Browns Ferry Nuclear Plant, Units 1, 2, and 3  
Renewed Facility Operating License Nos. DPR-33, DPR-52, and DPR-68  
NRC Docket Nos. 50-259, 50-260, and 50-296

**Subject: Browns Ferry Nuclear Plant, Units 1, 2 and 3, License Amendment Request to Revise Emergency Plan Staff Augmentation Times (TS-515)**

License Amendment Request to Revise Emergency Plan  
Staff Augmentation Times (TS-515)

FIGURE A-3  
TECHNICAL SUPPORT CENTER (SAMPLE)

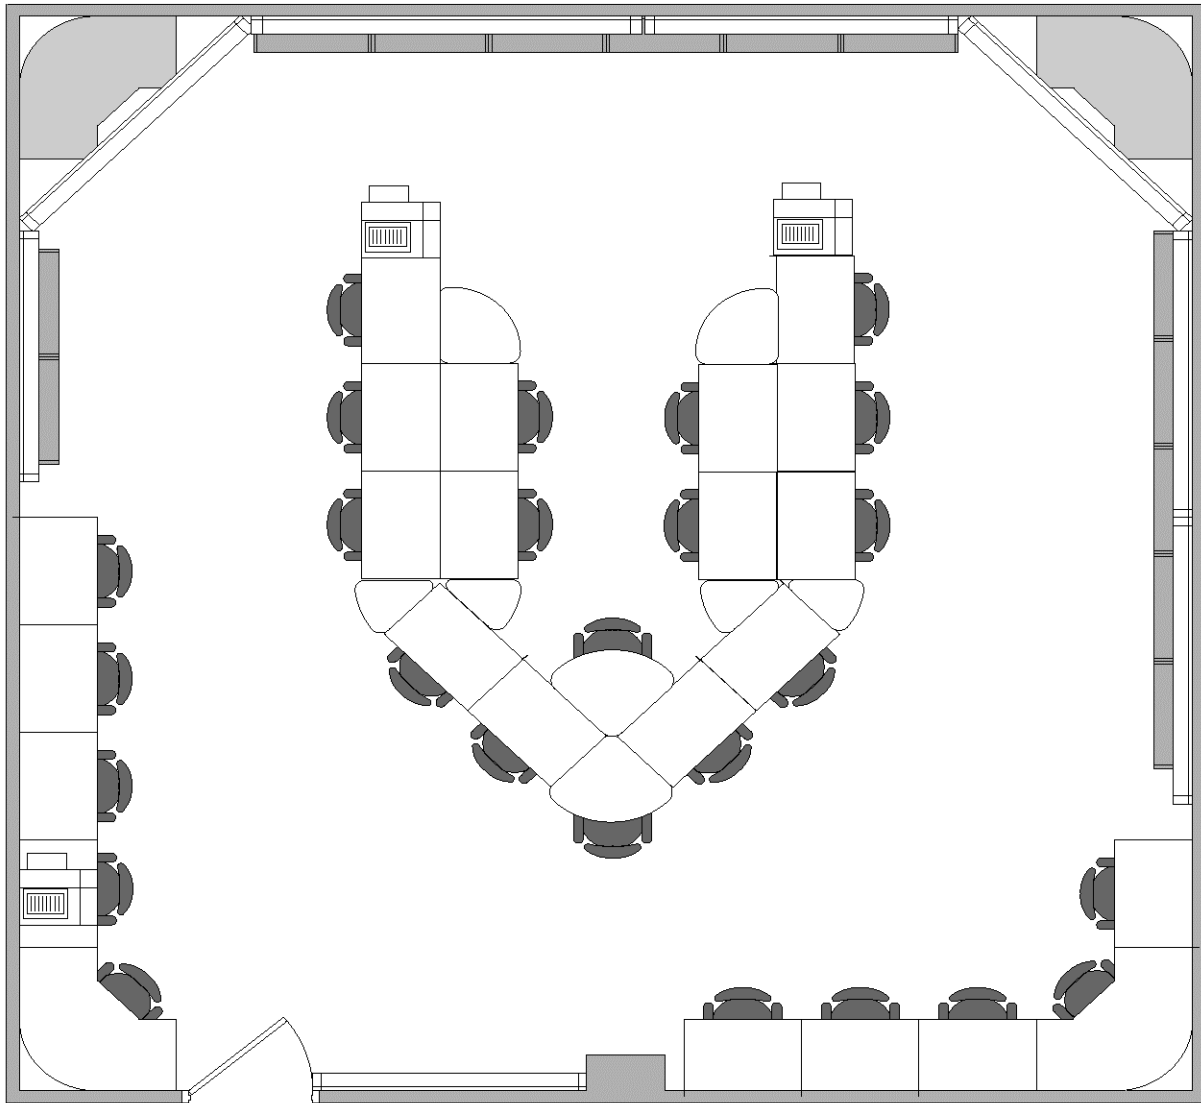
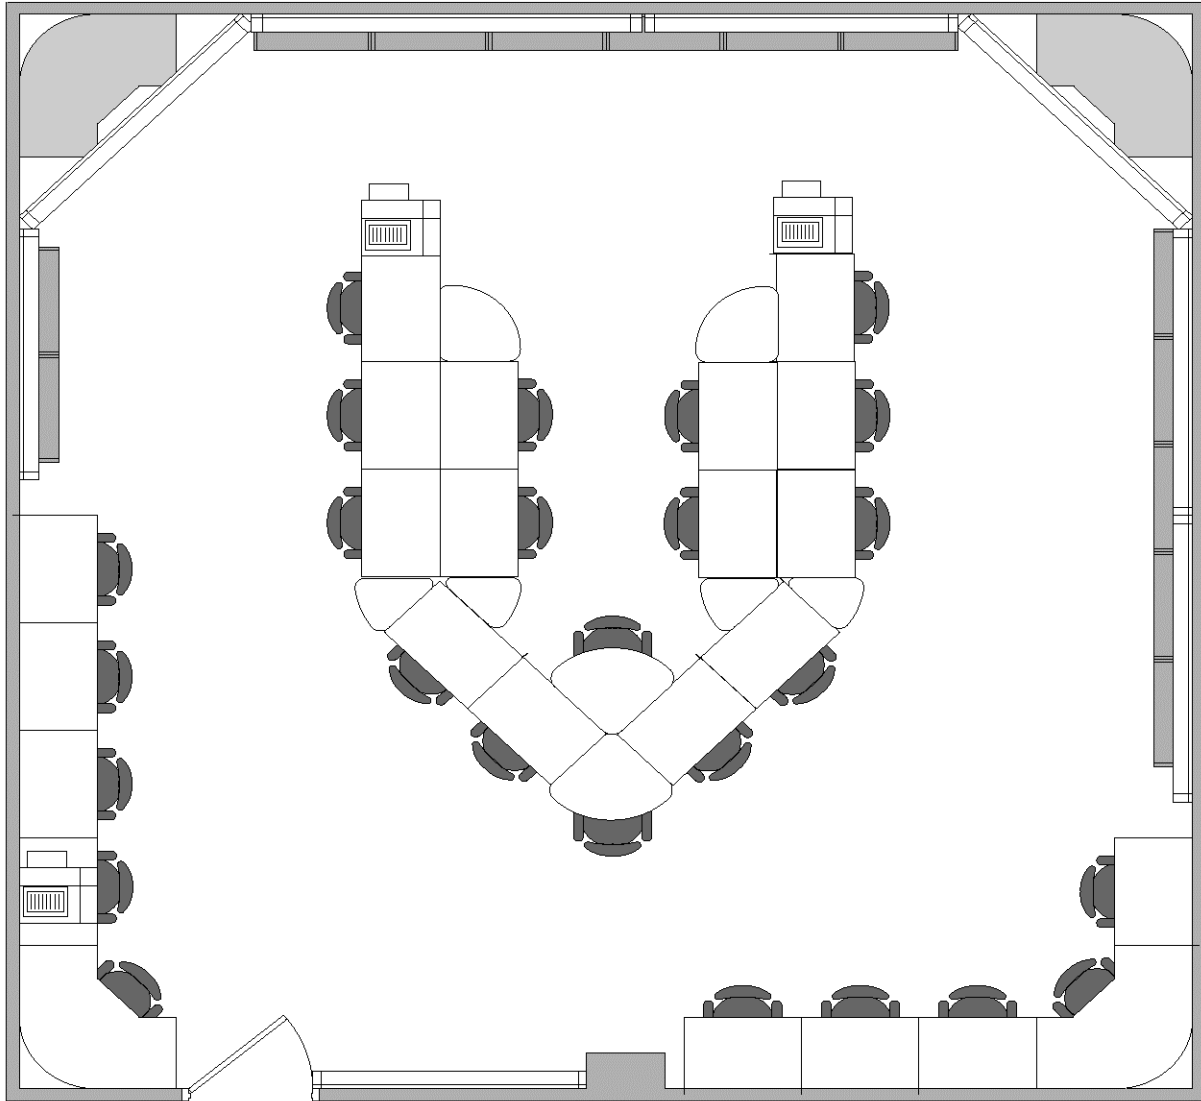
- r. Appendix A, Figure A-3, "Technical Support Center," revised to add the word 'Sample' to title to identify acceptability of other facility configurations as needed and removed assignments list to align with proposed ERO changes

FIGURE A-4  
OPERATIONS SUPPORT CENTER (SAMPLE)

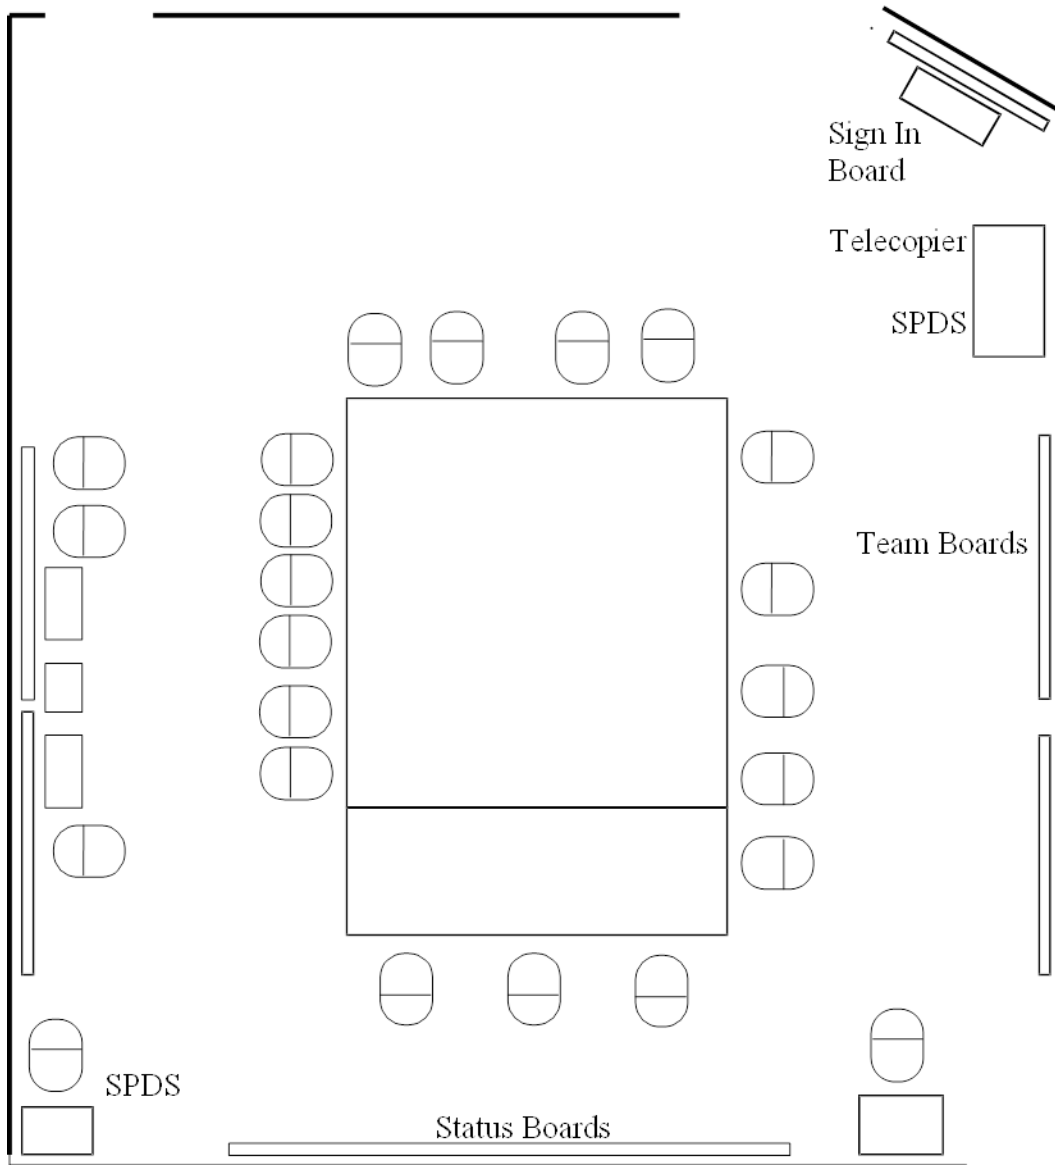
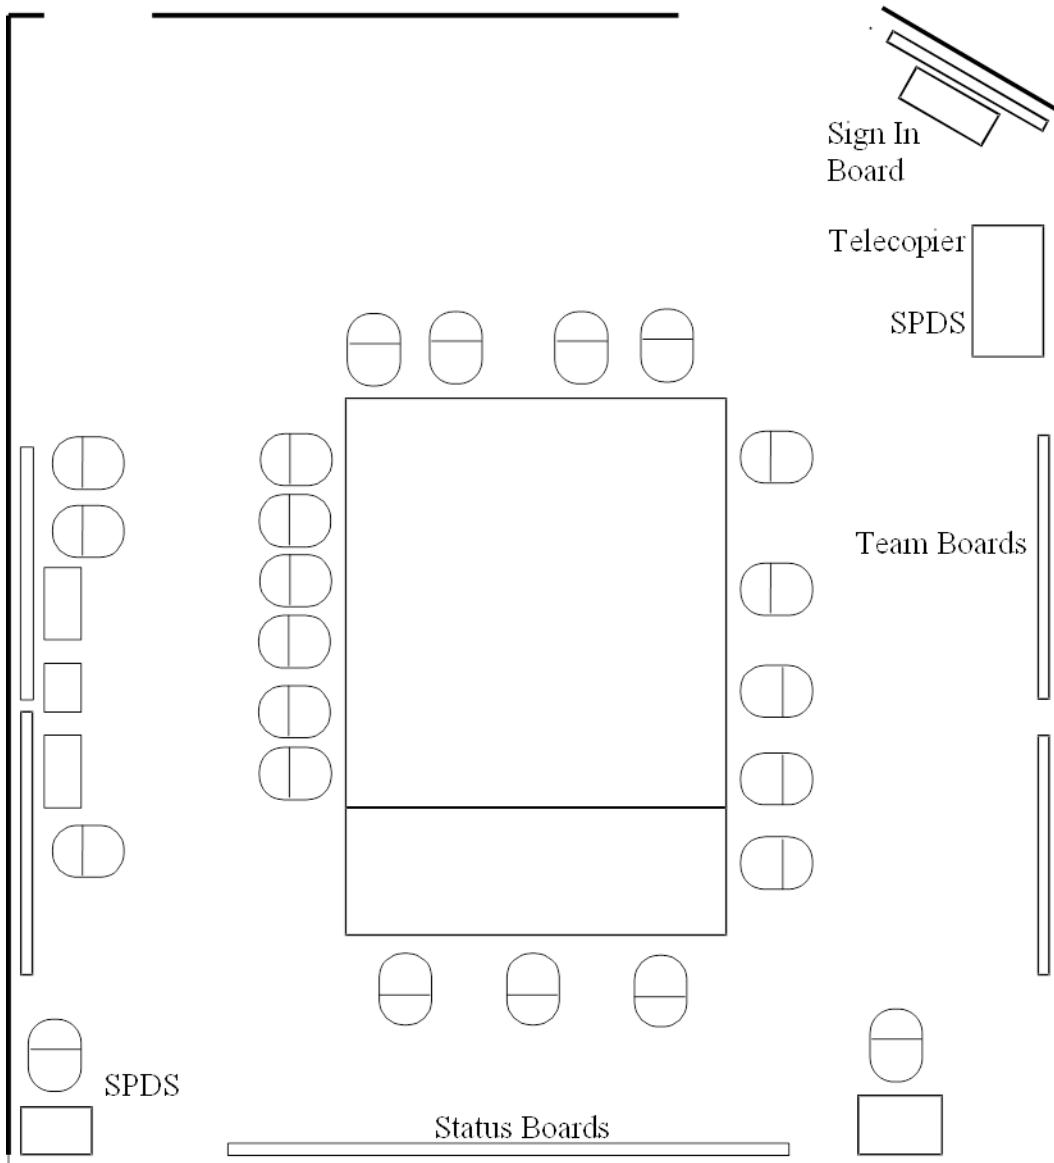
- s. Appendix A, Figure A-4, "Operations Support Center," revised to add the word 'Sample' to title to identify acceptability of other facility configurations as needed and removed assignments list to align with proposed ERO changes.
